RECREATIONAL VEHICLE CUSTOMER SATISFACTION

Customer Satisfaction Campaign: 22-425

CUSTOMER SATISFACTION CAMPAIGN

Fig. 1

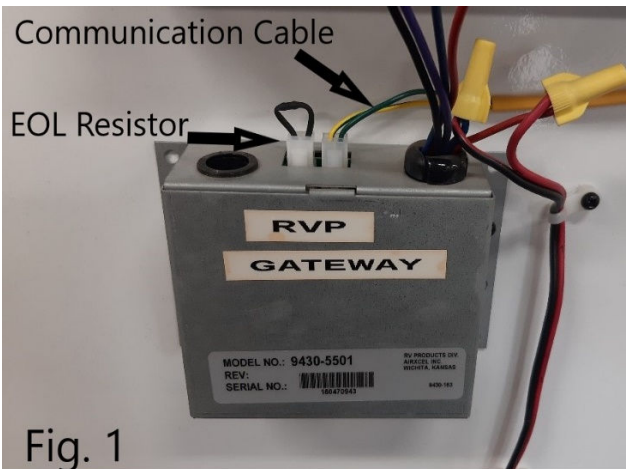
Figure 1-Shows a Gateway, the communication cable from In-Command system and the EOL resistor as it should be for proper operation.

4. Note: When a 2nd A/C is installed later, unplug the EOL resistor from the 1st Roof A/C Gateway, reinstall the 2nd A/C communication cable. Install the Pre-wired Communication cable and the EOL resistor into the 2nd A/C Gateway as seen in Figure 1.

Fig. 2

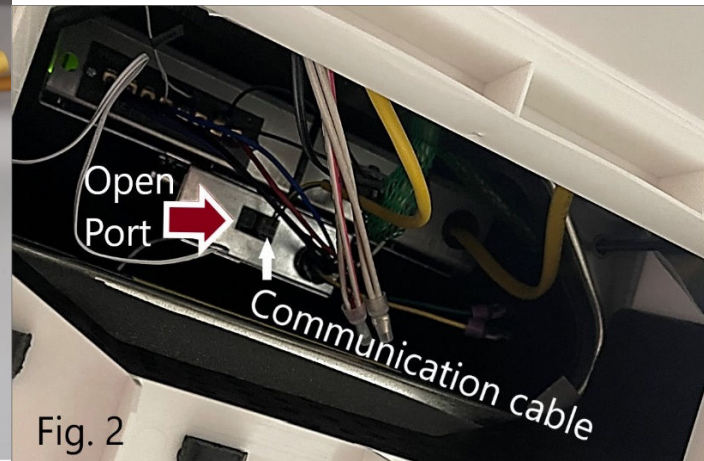
1. System with one Roof A/C. Turn off the A/C, remove the return air grill, and locate the Gateway (See Figure 2). If there is an open port as seen in Figure 2 & 3, corrective action is needed. Upon completion, the wiring should be as seen in Figure 1.

Fig. 4

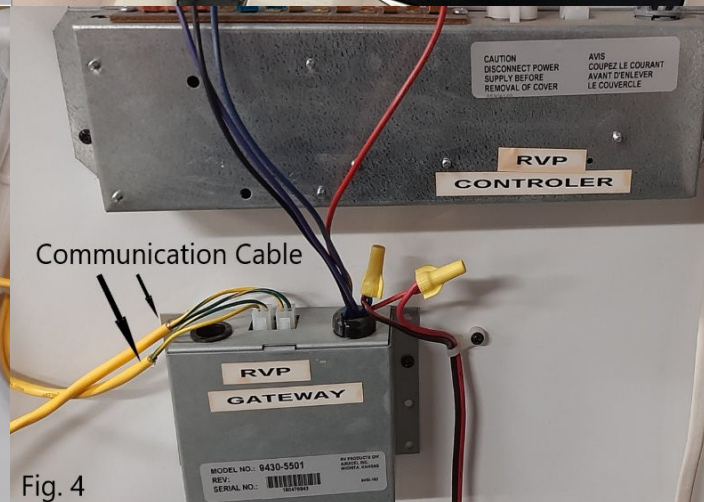
2. System with two Roof A/C's. Turn off the A/C's, remove the return air grill, and locate the Gateway's. The EOL will need to be installed on the 2nd A/C's Gateway. The first A/C Gateway (typically the middle of the unit) will have two communication cables plugged in (See Figure 4). One cable from In-Command to the 1st A/C, one cable from the 1st A/C to the 2nd A/C. The second A/C Gateway should look like Figure 1, if not, take corrective action.

3. System with one Roof A/C and Pre-Wired for 2nd A/C. If Pre-Wired for 2nd A/C, the 1st A/C Gateway may have two communication cables plugged in, See figure 4. One cable from In-Command to the 1st A/C, one cable from the 1st A/C to the 2nd A/C. The 2nd A/C communication cable will need to be unplugged and the EOL Resistor will need to be plugged in to that port. See Figure 1. The 2nd communication cable can be left protected and unplugged. To determine which communication cable is "live" unplug one cable at a time and operate the A/C functions at the In-Command panel.
